ADDENDUM #1

SUBJECT:
ADDENDUM #1
HAINESPORT SCHOOL RENOVATION
Hainesport Township BOE
RYEB Project #5288A

HAINESPORT SCHOOL RENOVATION
REGAN YOUNG ENGLAND BUTERA, PC PROJECT #5288A

WSK1.0

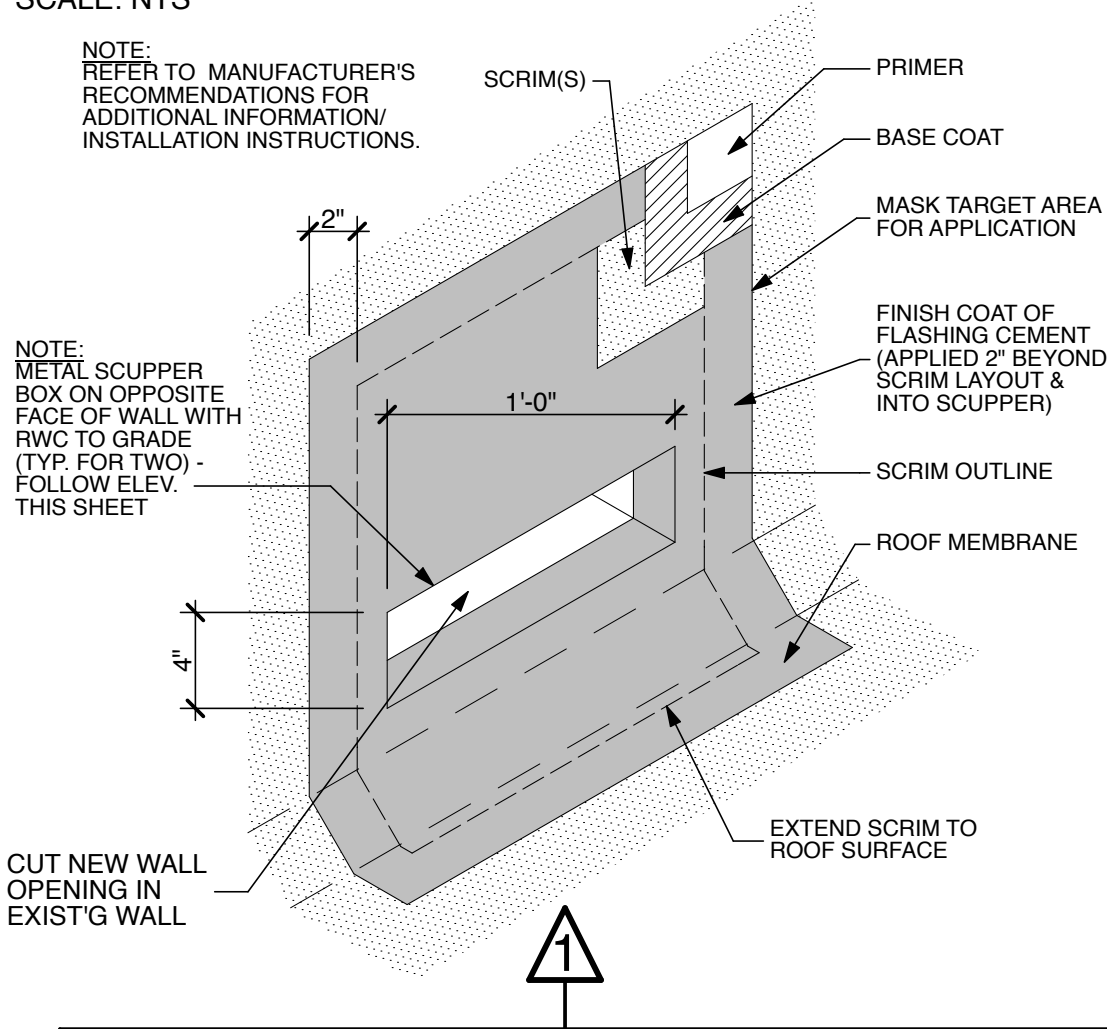
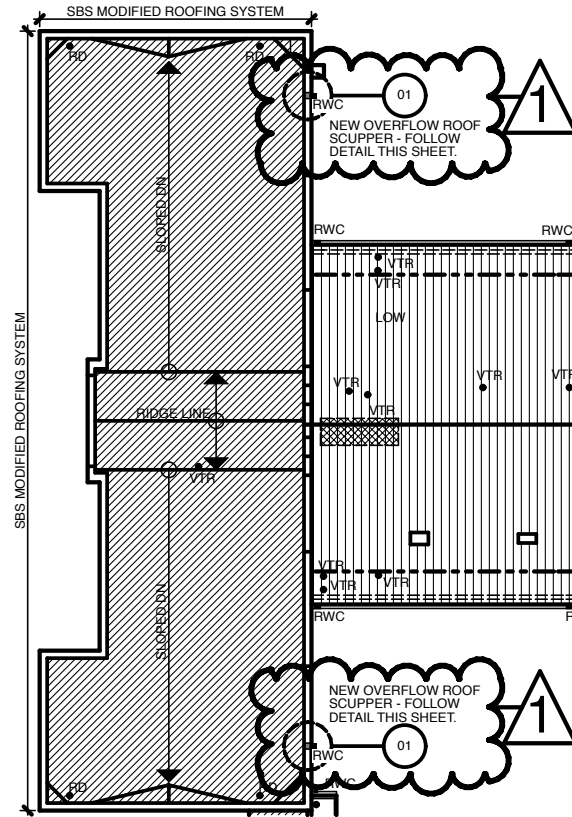
- 1.07 ADDITION: (Reference to attached WSK-1): Two emergency overflow roof scuppers have been added to the 1925 section of the school as shown on the attached WSK-1.

0.125 PREFIN. ALUM. SCUPPER BOX WITH WELDED SEAMS - 24"W x 12"H x 8"D (TYP. FOR TWO)

NOTE:
METAL SCUPPER BOX ON OPPOSITE FACE OF WALL WITH RWC TO GRADE (TYP. FOR TWO) - FOLLOW ELEV. THIS SHEET

OVERFLOW SCUPPER DETAIL
